# UNITED STATES PATENT AND TRADEMARK OFFICE

# Office Action Summary

Application No.  
09/975,417

SWIFT

## **A**

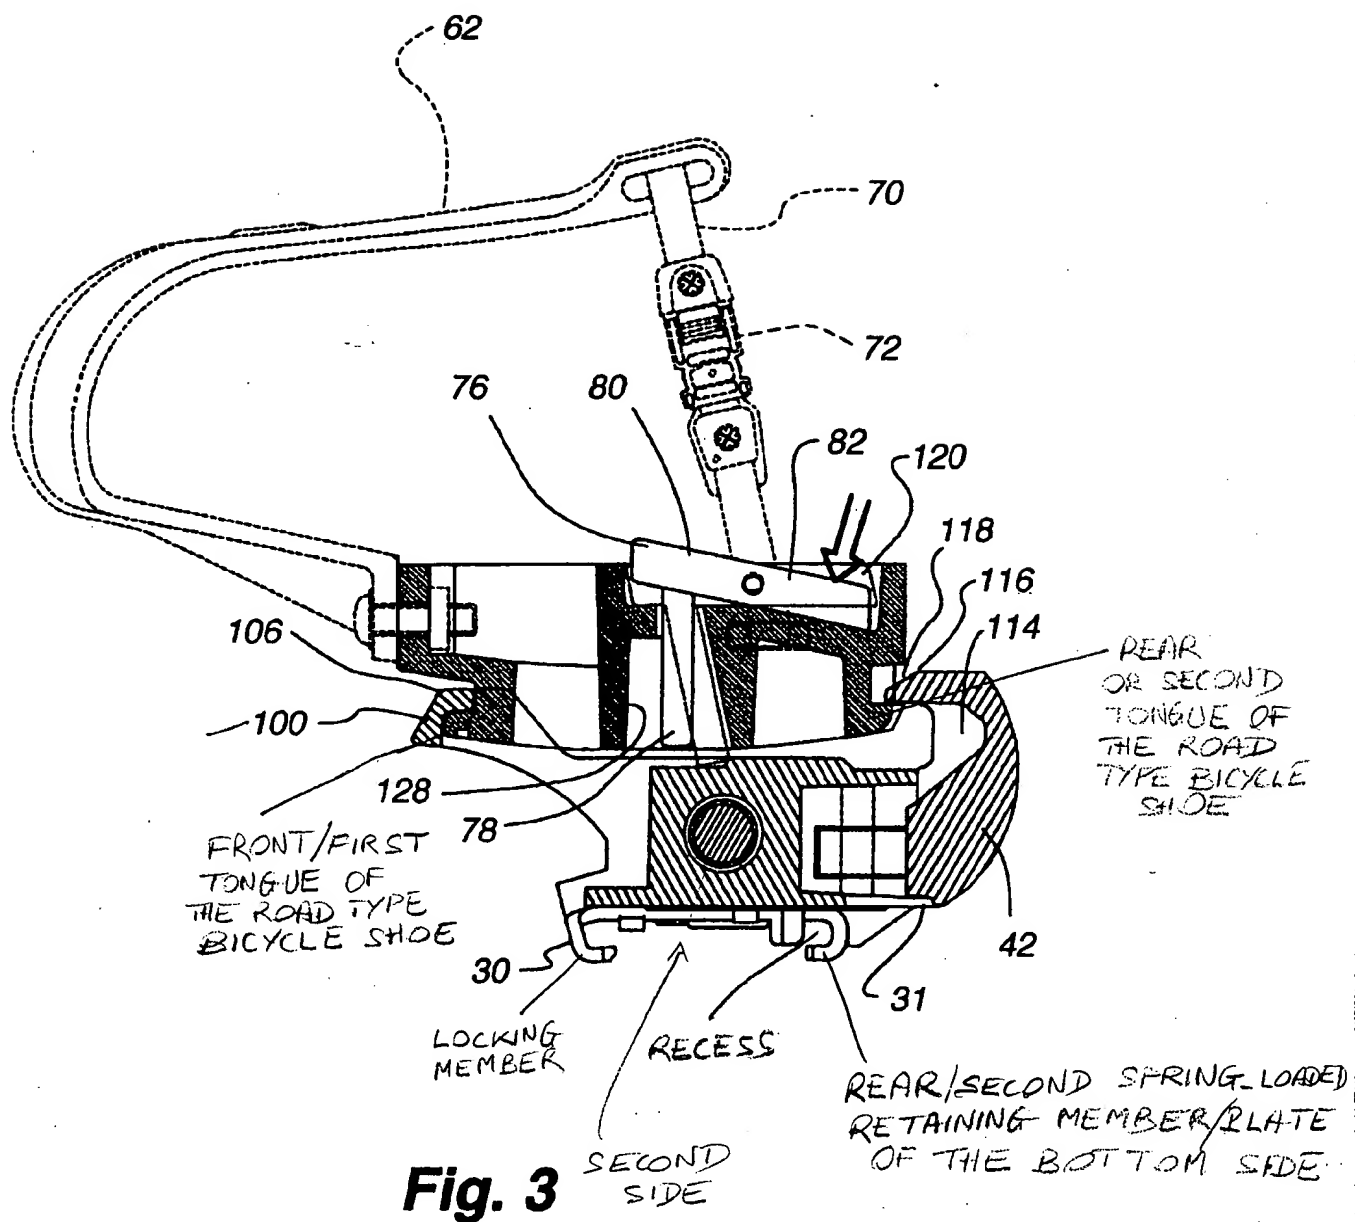
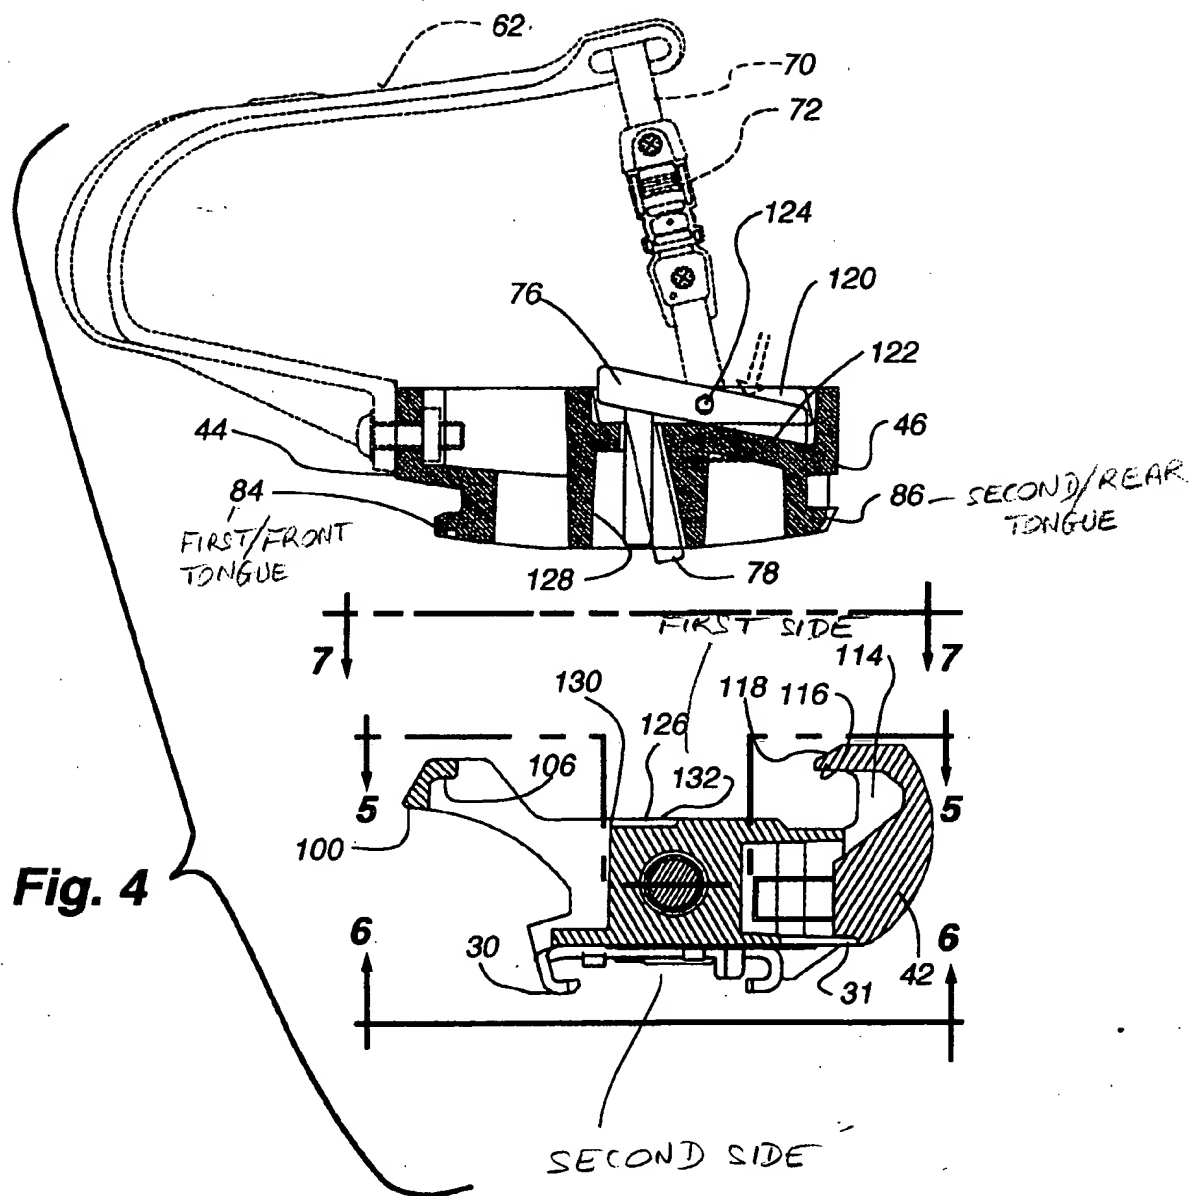
b. said first side 28 conforming to a bottom of a road type bicycle shoe cleat 22 and having means 100, 106 for receiving a first tongue 84 (Attachment A) of the road type bicycle shoe cleat 22, said first side 28 also having a first spring-loaded retaining plate 42 pivotable on the main body 24 for receiving a second tongue 86 of the road type bicycle shoe cleat 22 and when a force is applied to the first spring-loaded retaining plate 42, the first spring-loaded retaining plate 42 moves away from said main body 24 such that the second tongue 86 is retained within the

**C**

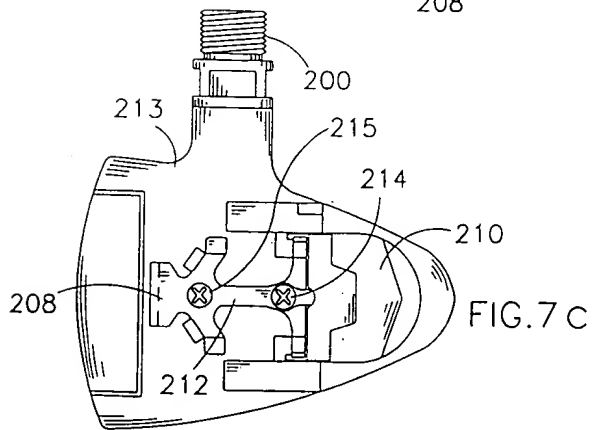
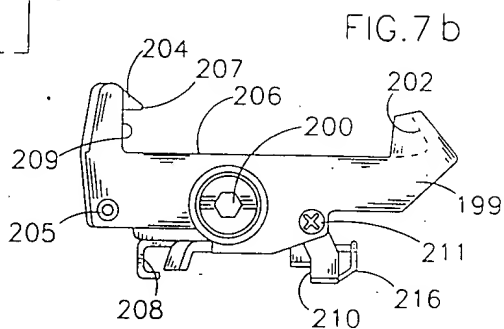
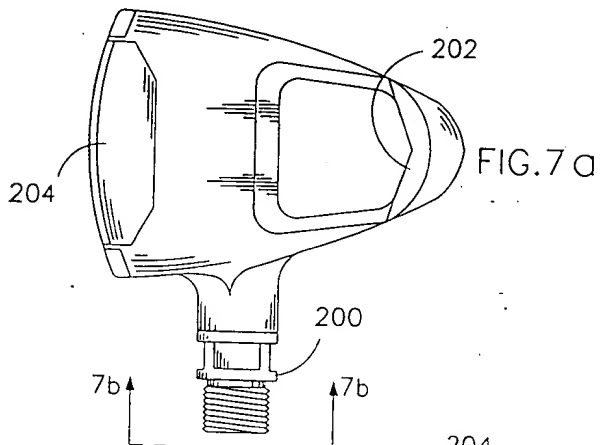
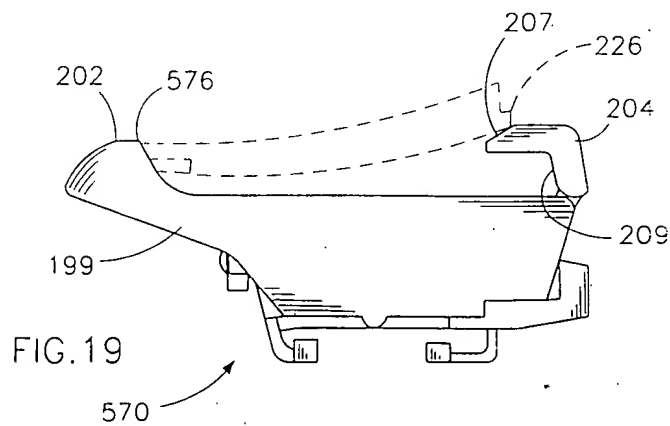
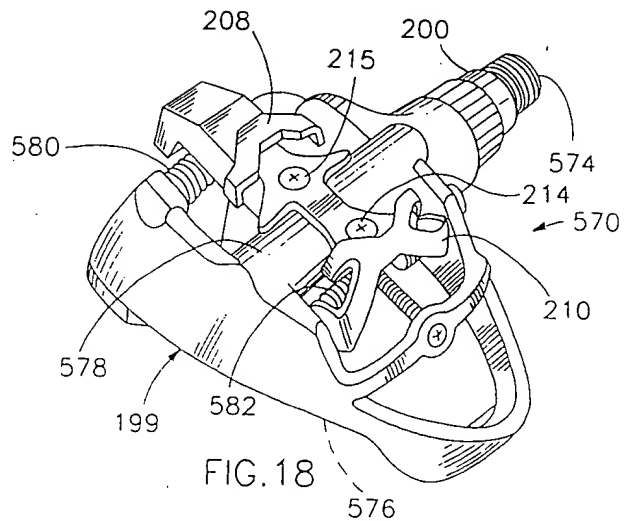
Second, applicant compares Figs. 18 and Figs. 7a-7c of this application and asserts that *"everything that the Applicant is disclosing and claiming in the present '417 Application was in fact disclosed in the original application filed on September 3, 1997."* (Page 11 of Paper 5).

Contrary to applicant's remarks, the comparison of Figs. 18 and Figs. 7a-7c of this application shows that *everything that the Applicant is disclosing and claiming in the present '417 Application was in fact not disclosed in the original application filed on September 3, 1997*. To illustrate this point, the examiner respectfully refers to Attachment C wherein Figs. 7a-7c are shown on the left side and Figs. 18 and 19 are shown on the right side. One may reasonably recognize that the spring plate 204 of the first pedal in Fig. 7b is patentably distinct from the spring plate 204 of the second pedal in Fig. 19 due to the pivoted recess 209 and the springs 580 and 582.

## **D**

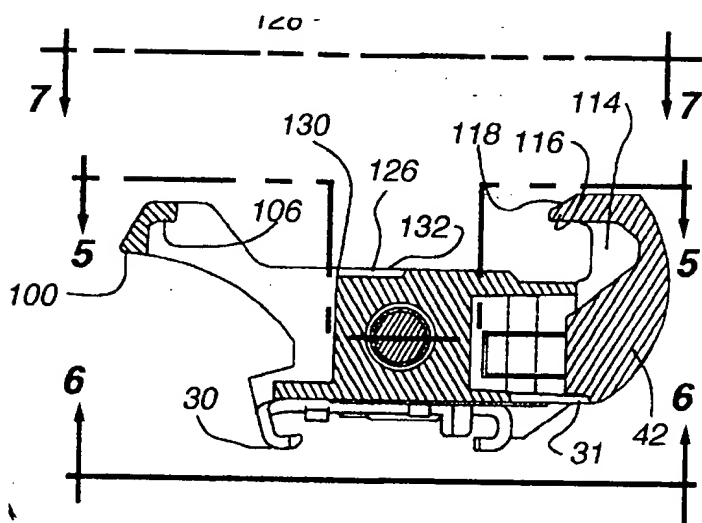
In the case at hand, applicant's recitation of the intended use of applicant's claimed invention does not result in a structural difference between the claimed invention and the prior art Gapinski. To illustrate this point, the examiner prepares Attachment D wherein applicant's claimed pedal in Fig.

19 is shown side by side with Gapinski's pedal. One may reasonably infer from Attachment D that Gapinski's pedal is substantially identical to applicant's pedal.
